PLANNING COMMISSION AGENDA REPORT JANUARY 18, 2024

FILE NO(s).: SPR-2019-005, OTP-2021-001, LLA-2021-003

PROPOSAL: Request for a Site Plan Review, Oak Tree Permit, and Lot

Figure 3: Current proposed design, front elevation.

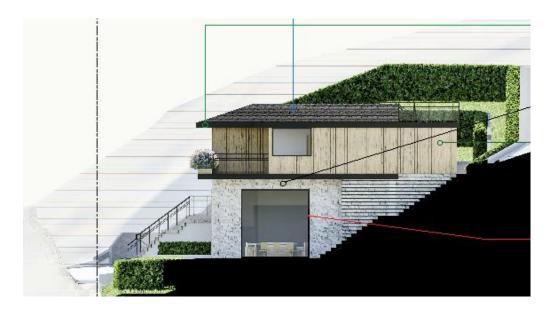
At the second ARP meeting on April 5, 2022, the applicant and his engineer presented minor adjustments to the plan and expressed their opinion that reducing the amount of grading was infeasible. The ARP's consensus was that the proposed project could in fact be revised to require less grading and export, and they recommended the applicant consider re-designing the project in a way that would require less grading. The ARP also expressed concerns regarding the bright white façade that was depicted on the first and second floors of the residence with this submittal.

Finally, prior to the third ARP meeting on November 18, 2022, the applicant worked with Planning and Public Works staff on a redesign that reduced the square footage of the proposed residence (from 3,204 SF to approx. 3,100 SF) and altered the east side yard area to change the configuration of side yard retaining walls and stairs. As a result, the total length of on-site retaining walls were reduced by 55% in comparison with the previously submitted plans, and the amount of proposed grading was reduced from 1,716 cubic yards of cut to 1,473 cubic yards of cut. The ARP recognized and appreciated that some of the major design comments from the two prior meetings had been addressed. But were still outstanding, including comments recommendation to: 1) revise the proposed white stucco building and retaining wall color to a less bright and reflective choice; 2) ensure all mechanical equipment and ducting will be screened; and, 3) improve articulation at the roofline and between the first and second floors. The ARP recommended approval, subject to the applicant revising the plans to address the outstanding comments, with final revisions to be reviewed by Chair Shepphird.

Following the ARP's third review, the applicant submitted revised plans (Figures 3 and 4) incorporating the above-mentioned suggestions, and the revised plans were sent to Chair Shepphird for review.

As currently proposed, the residence includes white quartz and white marble at the first-floor façade, wood siding on the second floor, black aluminum door/window trim, a charcoal shingle roof, and natural-colored concrete retaining walls. The white stucco has been removed, area of white quartz/marble has been reduced, and white finish on retaining walls has been removed

following the ARP's feedback; the length and number of retaining walls has also been substantially reduced, and wood siding and a planter box have been incorporated at the second floor to better differentiate the first and second floors (See Sheets A301-A303 of Exhibit A).
